(12) **United States Design Patent** (10) **Patent No.:** **US D877,930 S**  
**Santamarta** (45) **Date of Patent:** **\*\* Mar. 10, 2020**

(54) **CONTAINER**

UNITED STATES PATENT AND TRADEMARK OFFICE  
**CERTIFICATE OF CORRECTION**

PATENT NO. : D877,930 S  
APPLICATION NO. : 29/672508  
DATED : March 10, 2020  
INVENTOR(S) : Santamarta

*FIG. 2*

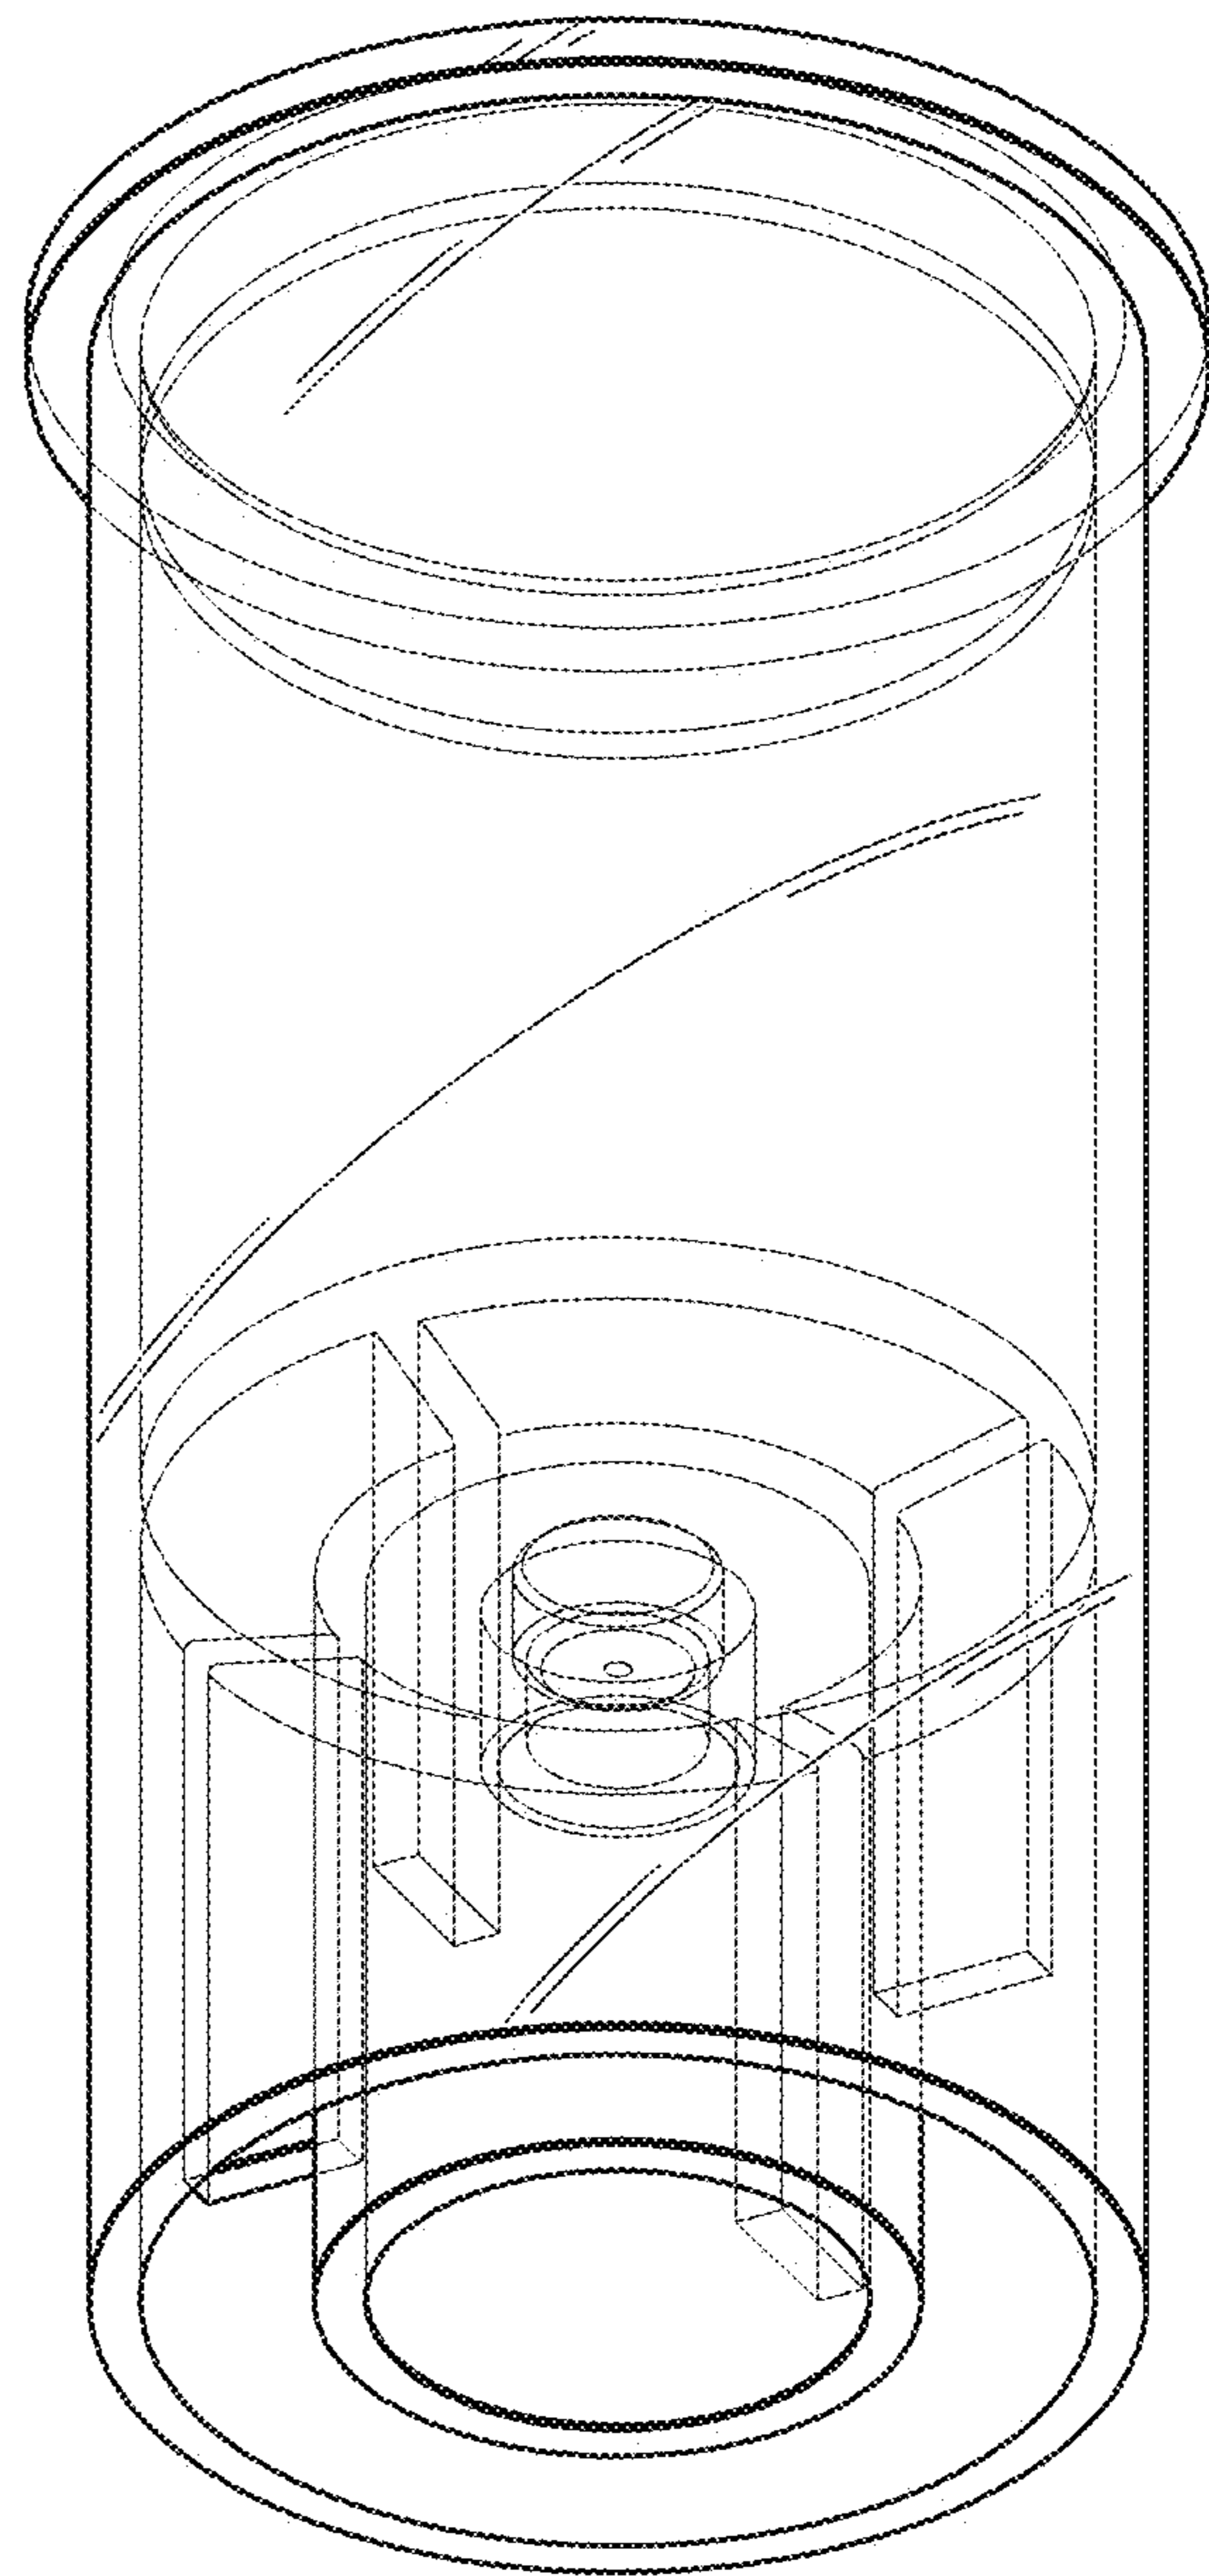
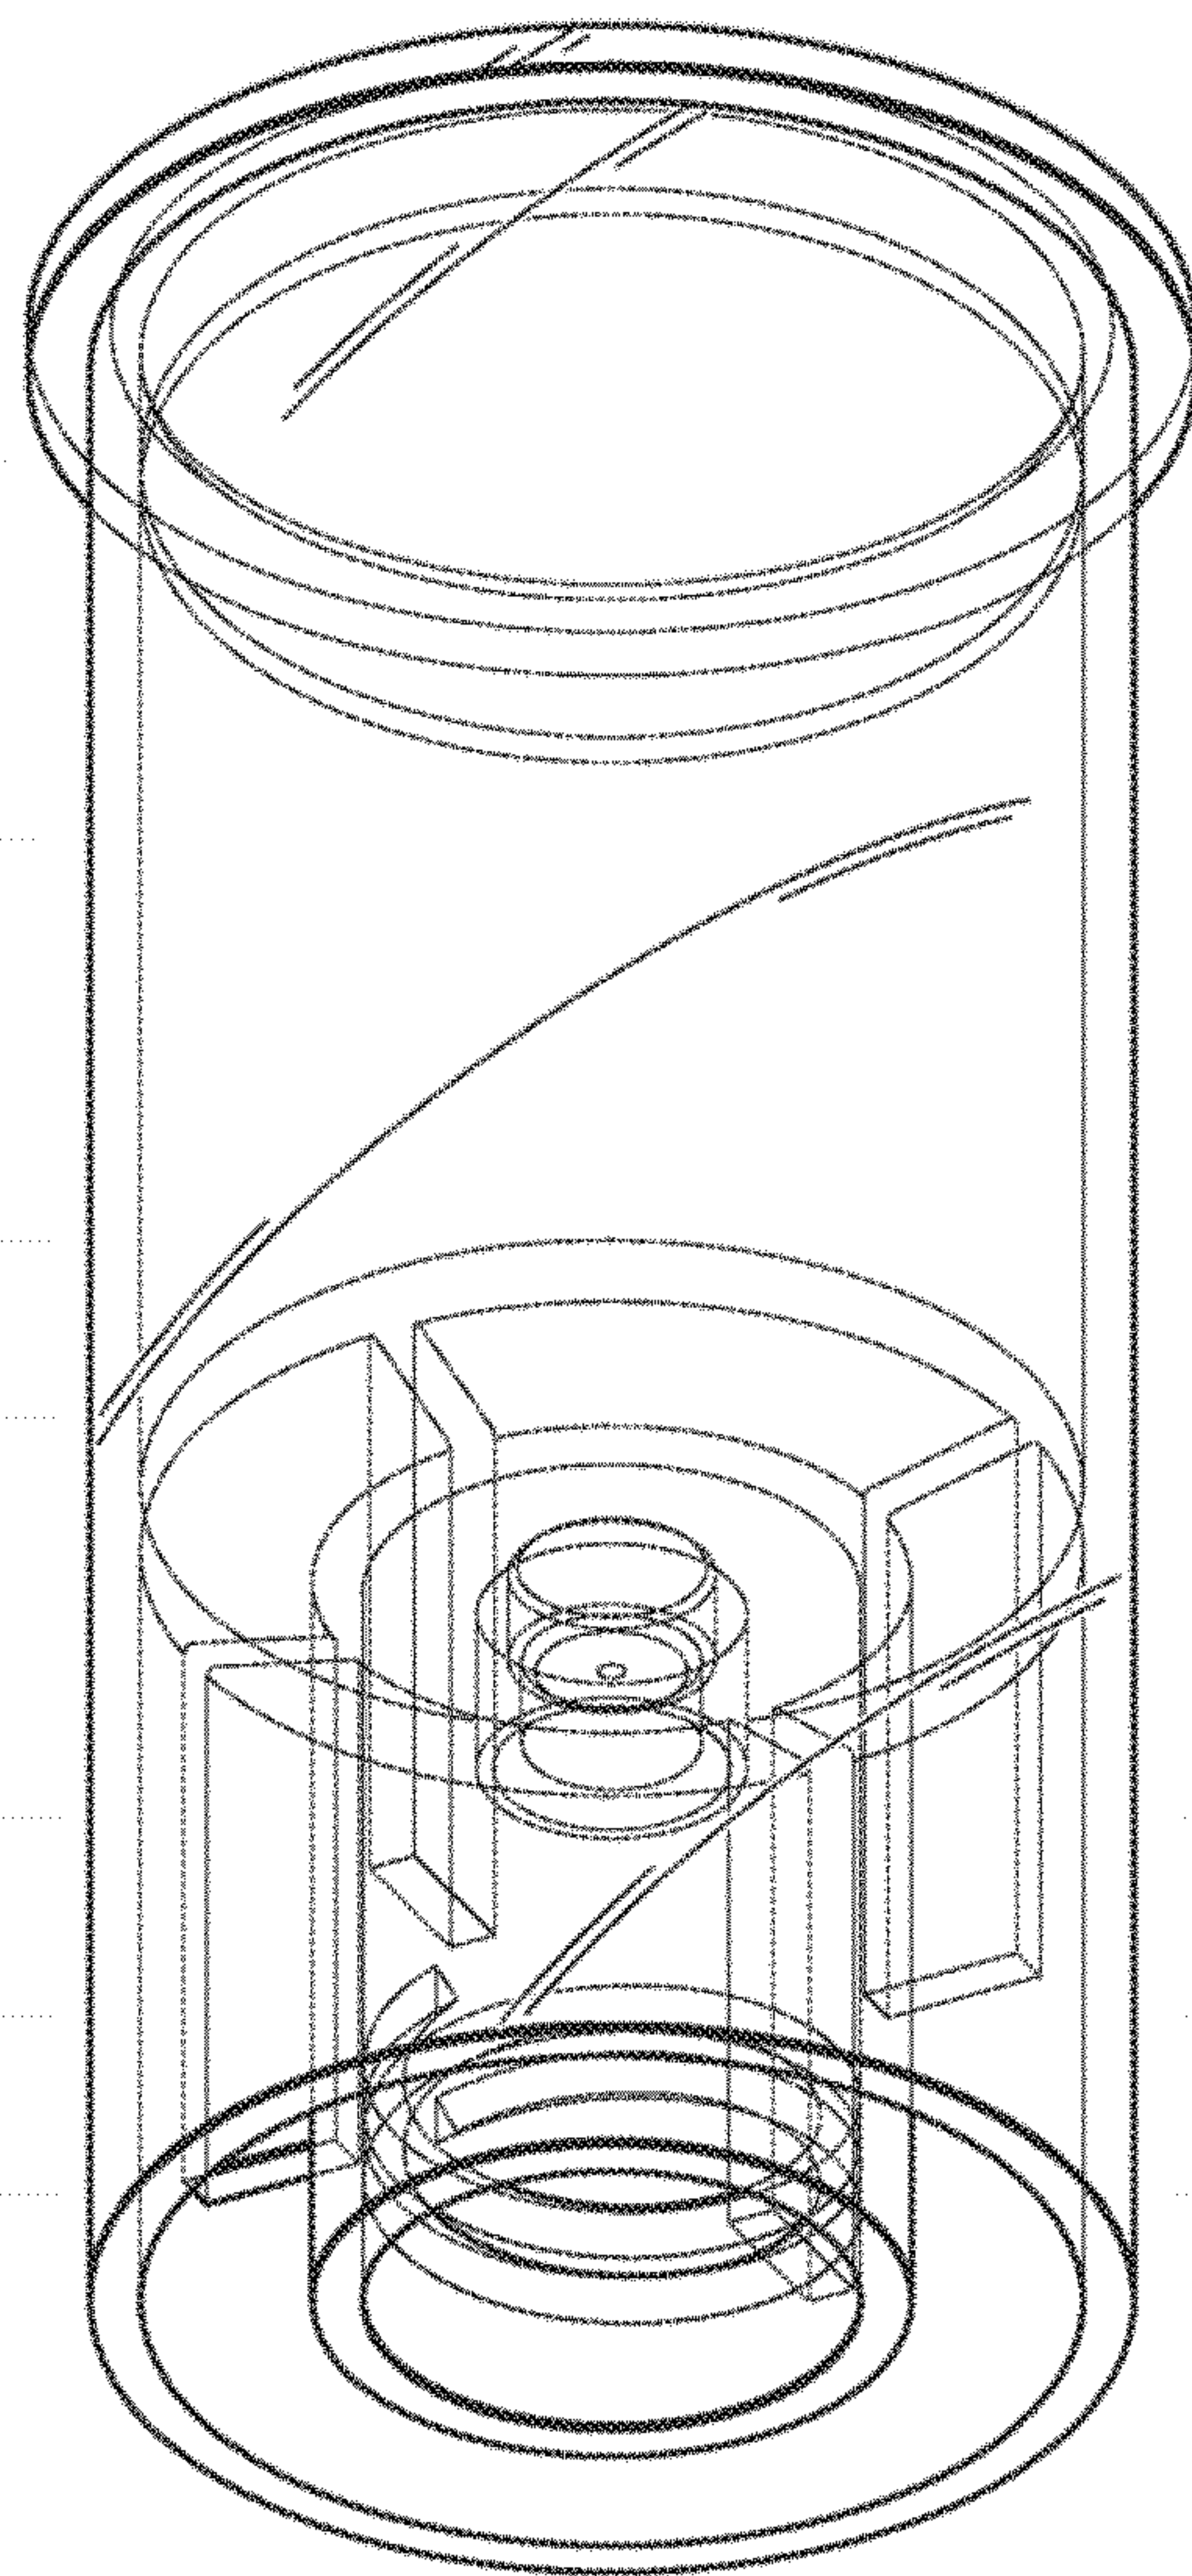
In Fig. 2, threading should be included near the bottom to reflect what is shown in Figs. 3 and 6 as shown on the attached drawing sheet.
